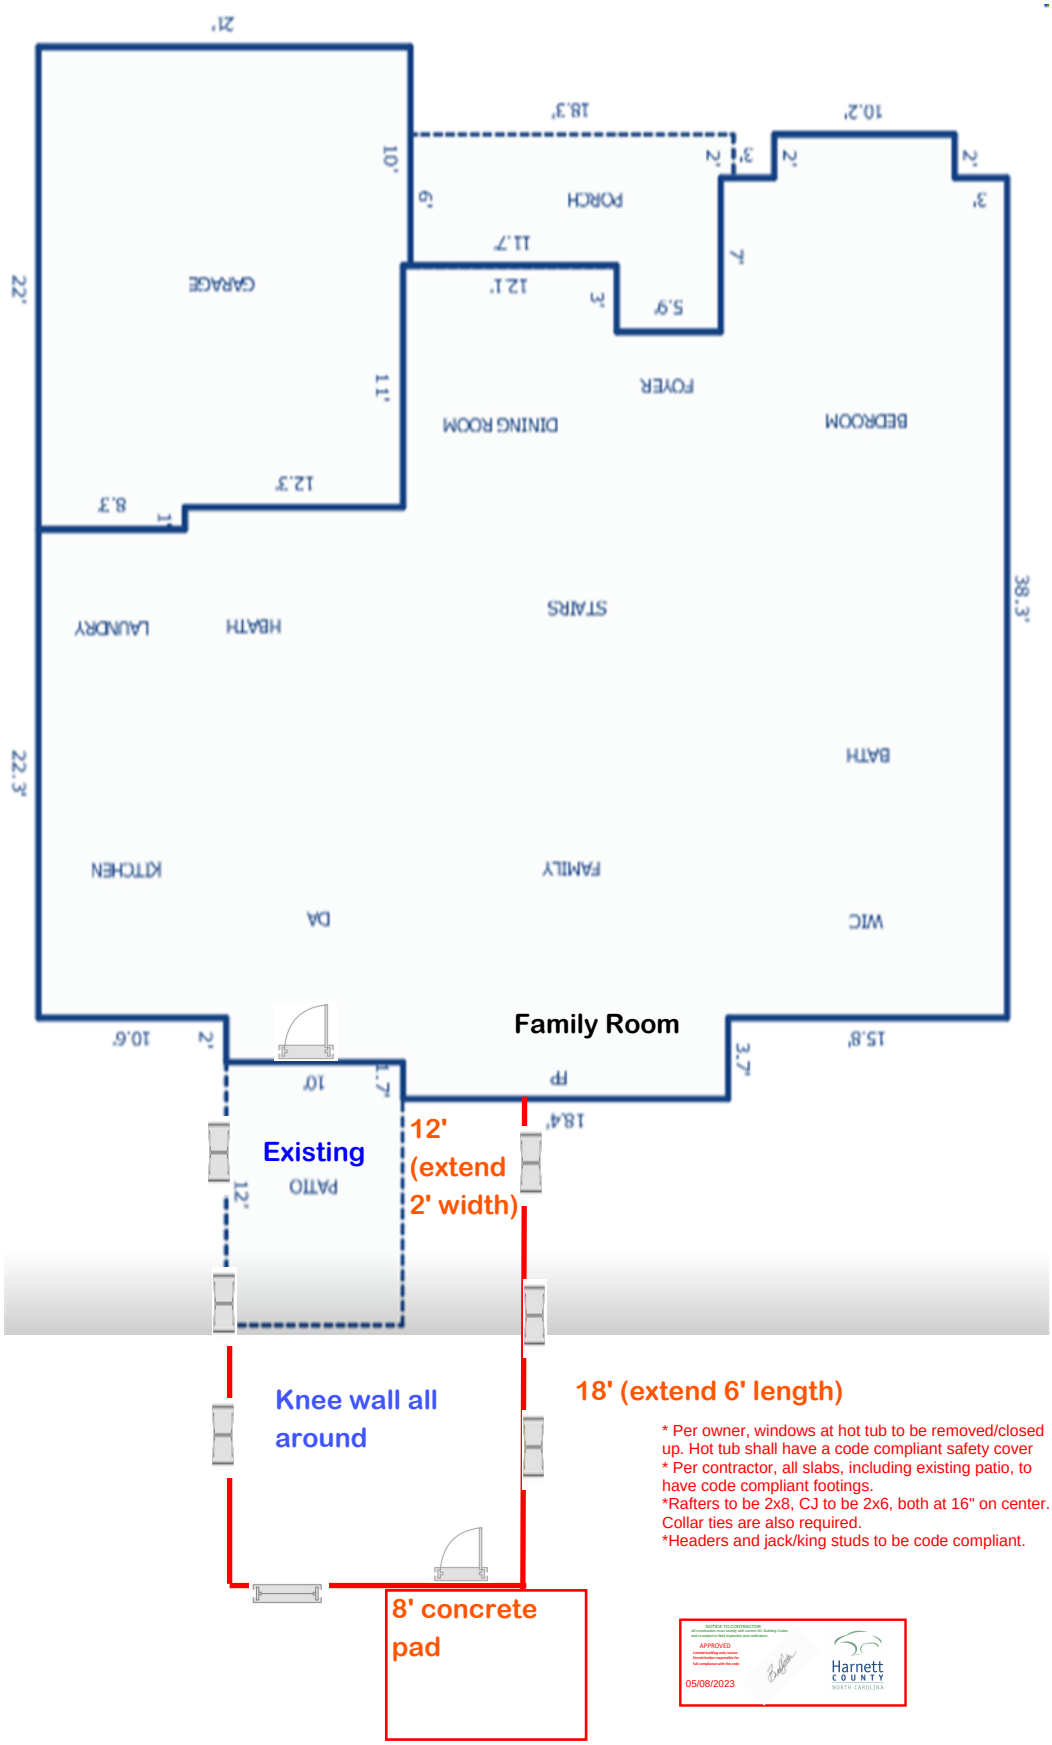
* Per owner, windows at hot tub to be removed/closed up. Hot tub shall have a code compliant safety cover
* Per contractor, all slabs, including existing patio, to have code compliant footings.
*Rafters to be 2x8, CJ to be 2x6, both at 16" on center. Collar ties are also required.
*Headers and jack/king studs to be code compliant.
